Reference: Pleasant Ridge Wind Energy Project  
Summary Review Report

Patrick Engineering Inc. (Patrick) has prepared this letter report to document our review findings on the Invenergy Pleasant Ridge Wind Energy Project proposal for Livingston County. As stated in our August 29, 2014 proposal letter, Patrick performed the following activities:

Reference: Pleasant Ridge Wind Energy Project  
Noise Study Updates with LNTE Turbine Blades

Reference: Pleasant Ridge Wind Energy Project  
Noise Study Review Update

Figure 2. Illinois Pollution Control Board (IPCB) limits at receptors versus anticipated maximum sound power levels within each octave band.

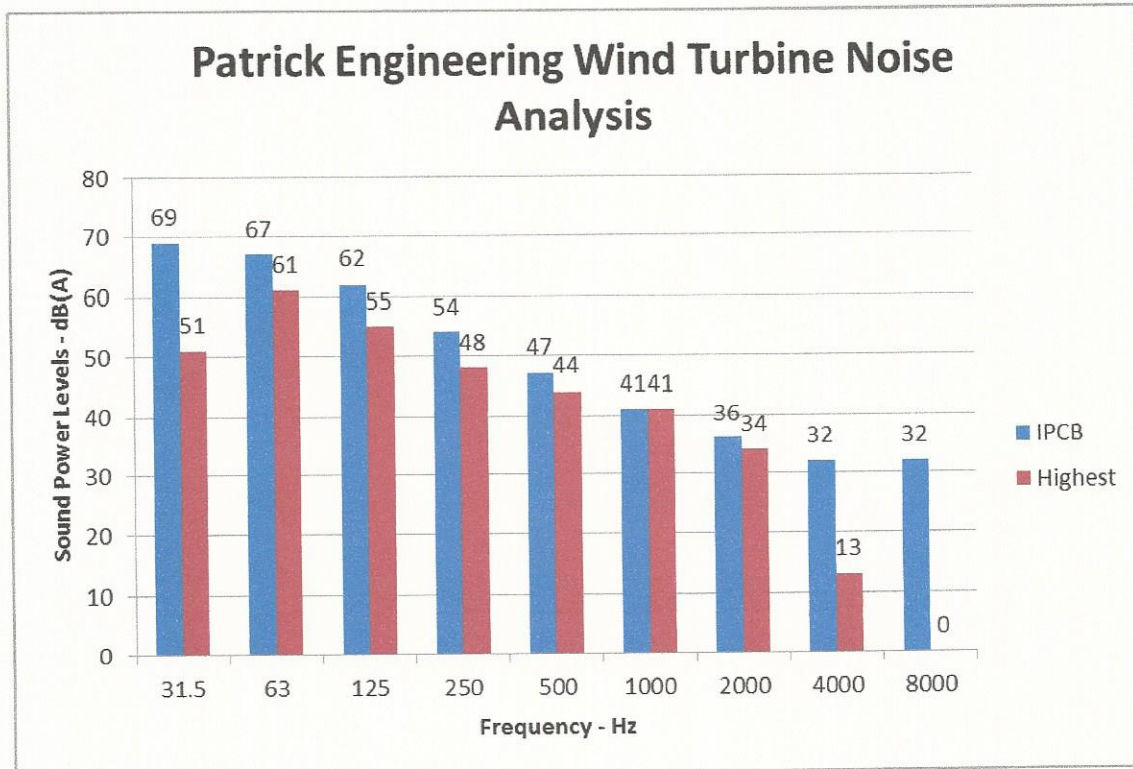
The application source and receptor data (furnished as part of the Invenergy Study) was reviewed for all locations, and a summary of the highest sound levels versus frequency band was created. This summary is plotted below in Figure 2 and shows that all the predicted levels are lower than or equal to the regulation.

Figure 3a. Sound predictions at Locations 009, 059, & 240 with Commercial or Business ambient sound pressures.

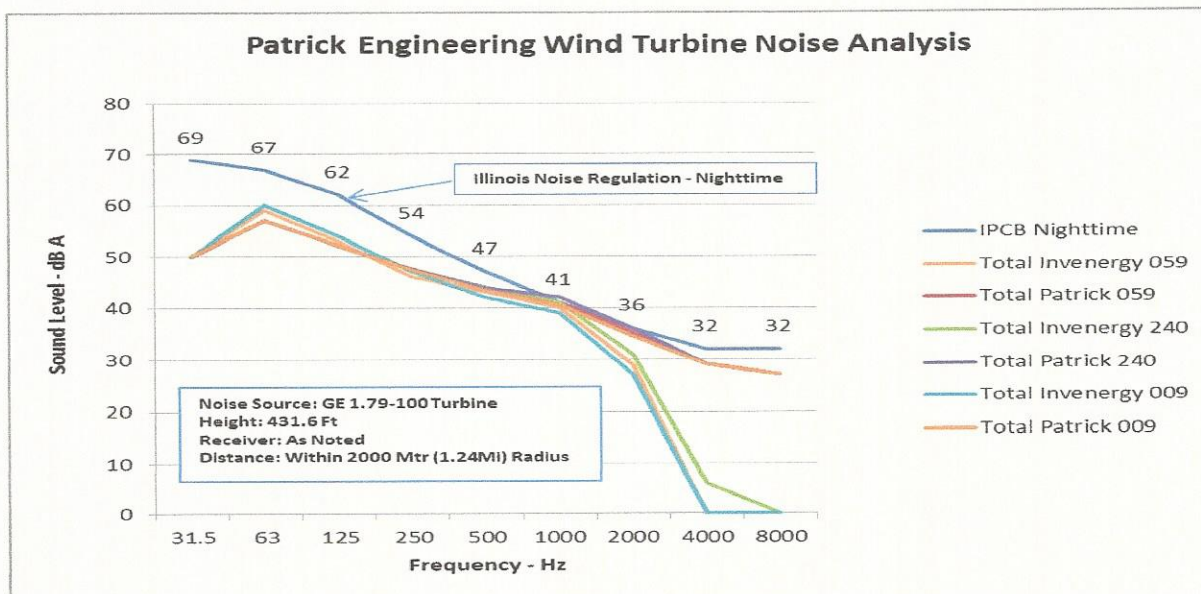
Results from the Invenergy noise study were validated using a commercially available and proven ISO 9613 modeling package<sup>3</sup>. The modeling package, SPM 9613 v2 by Power Acoustics, Inc., was used to predict the sound levels at the following three (3) receiver residential locations - locations R009, R059, and R240. These locations were independently modeled by Patrick. The results from the Stantec study along with the predicted values from the Patrick model are shown in Figures 3a, 3b, 4a, and 4b.
